Agency Comments Since October 4, 2012

Subject: Volcano Heights Sector Development Plan Comments

PNM appreciates the opportunity to review and provide comments on the draft *Volcano Heights Sector Development Plan August 2012* (Plan) for the City of Albuquerque. This letter provides our comments for your consideration on the Volcano Heights Sector Development Plan (VHSDP).

Exhibit A.41 – Volcano Mesa Area Electrical Facilities Map

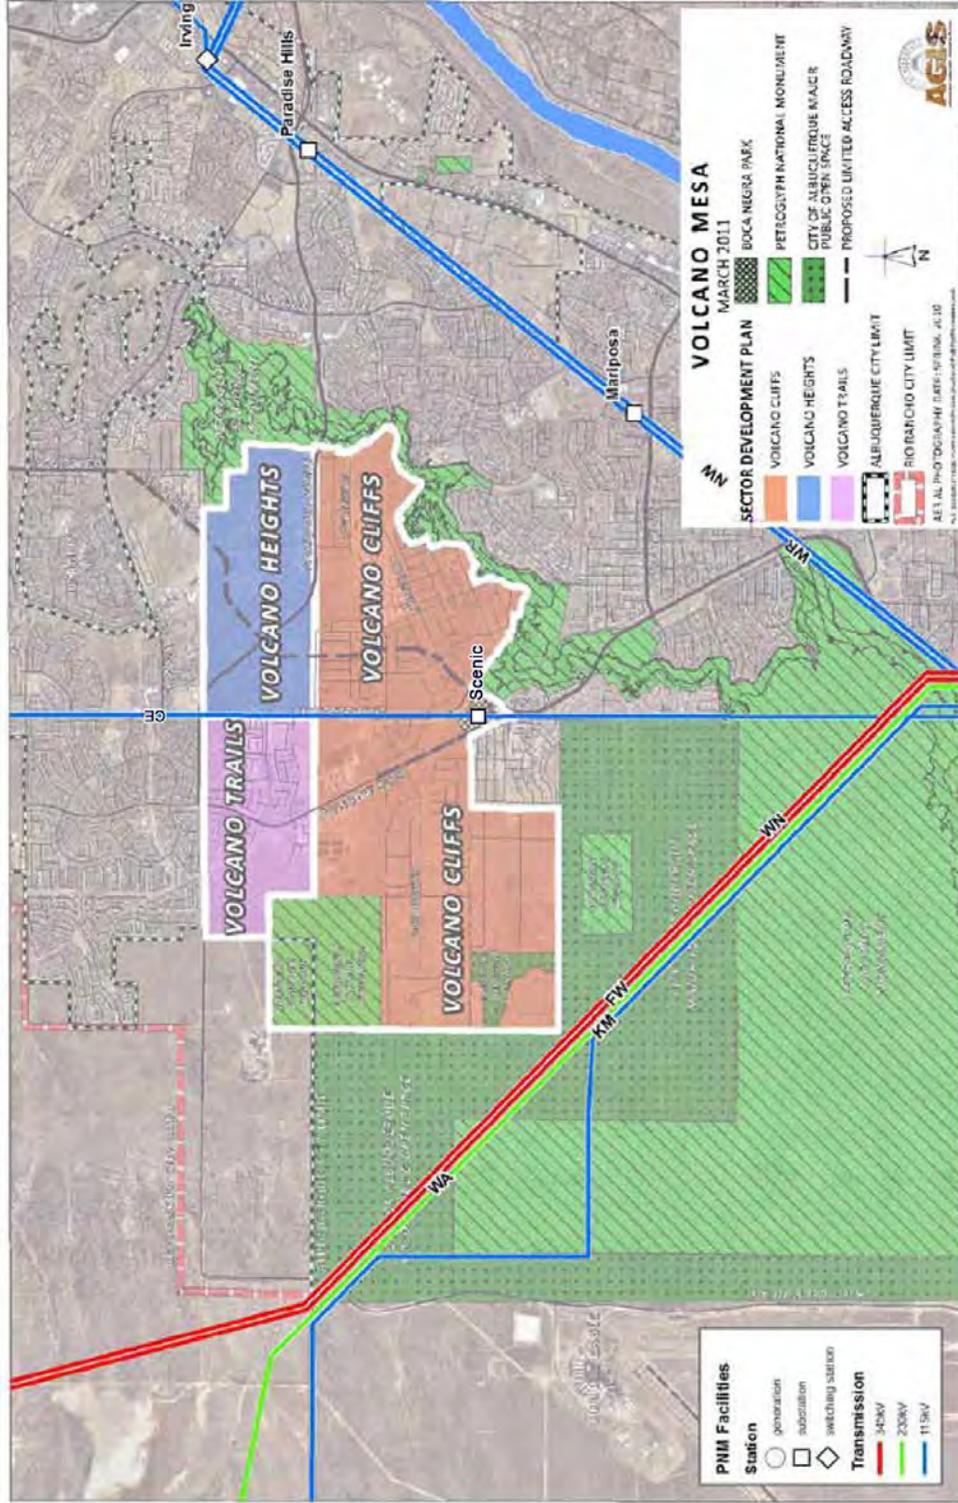
29. New facilities have been approved since the draft Plan’s Exhibit A.41 on page A-38 was created. Please replace Exhibit A.41 in the Plan with the enclosed revised Exhibit A.41 which indicates the location of the approved Scenic Substation under development.

- New lines are planned primarily to increase system reliability and serve new stations. New stations and lines are planned to serve load growth in developing areas. PNM has electric facilities within the Plan area as shown in Exhibit A.41 on page A-38. There is an existing 115kV electric transmission line with an approximate right-of-way width of 100 feet on the western boundary of the Plan area and a new substation called Scenic Substation is under development as of 2012.
